Company Name:	MRMLLP	Site	Gulmohar Residency
Name of the customer	Praneeth Mada		
Flat No.	D-501		
S.No	Description	Amount	
	Total extra Charges	48,055	
	Total refundable amount	—	
	Net amount to be charges (if any)	48,055	
	Net amount to be refunded (if any)	—	
Approved by Project Manager	Approved by Design Team	Approved by MD	
APPROVED BY	Date	Date	
14 APR 2023	Sign:	Sign:

Details of Additions & Alterations

Flat No	501	Block no.	' D ' ✓
Flat Area	1660 sft	Type	Deluxe / luxury
Buyer Name	Praneeth Mada		
Phone No.	9490039400	Email

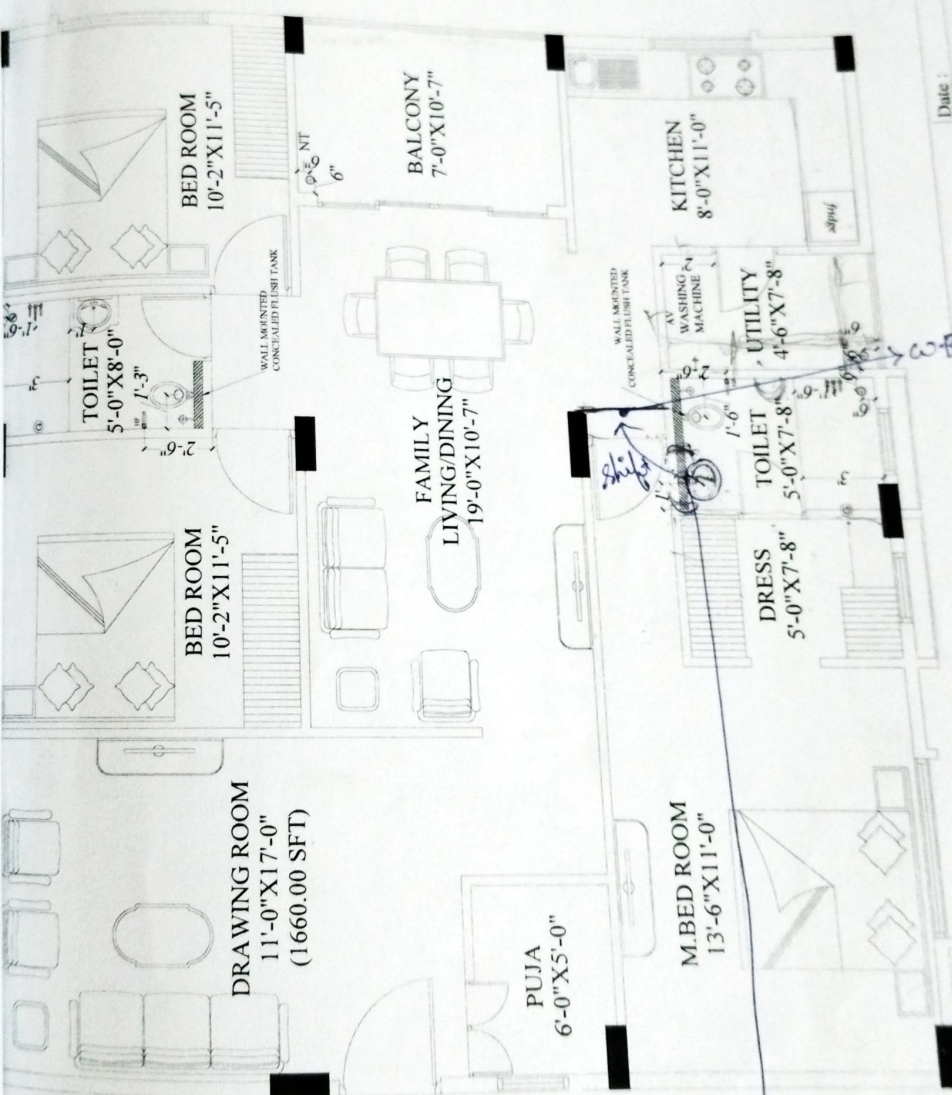
- ① Main Toilet Door to be changed.
- ② Platform in Utility.
- ③ Increase 1st length for childrens Bedroom.
- ④ Left in kitchen after removing Utility walls.
- ⑤ Dressing room no need.

need w.b point.
(w.b by Customer).

Promoted by Modi Perception Pvt Ltd		923
Date : 04.09.20	Prepared By : Jayapratha	723
Approved By : Sachin Modi	Scale : N.T.S	nikiran
Project Name & Phase : Gulmohar Residency		rendar
Owners & Developers : Modi Reality Mallapur LLP		
Direction : N		
Description		
PLUMBING PLAN-1660 Sft (B2-TYPE)

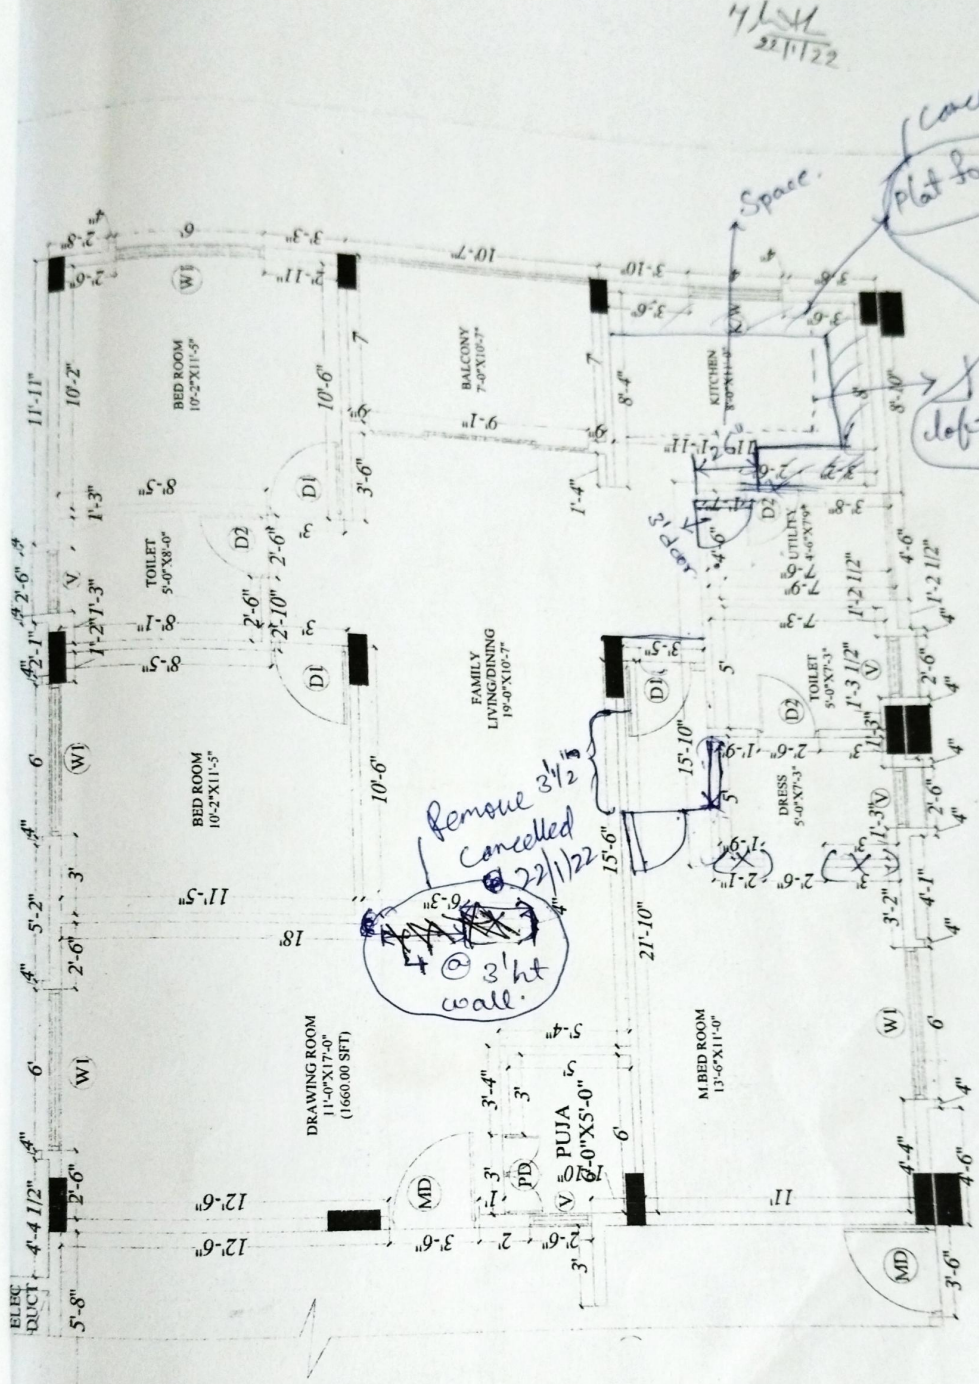
D-501.

Cancelled
22/1/22
Plat form

doft x post
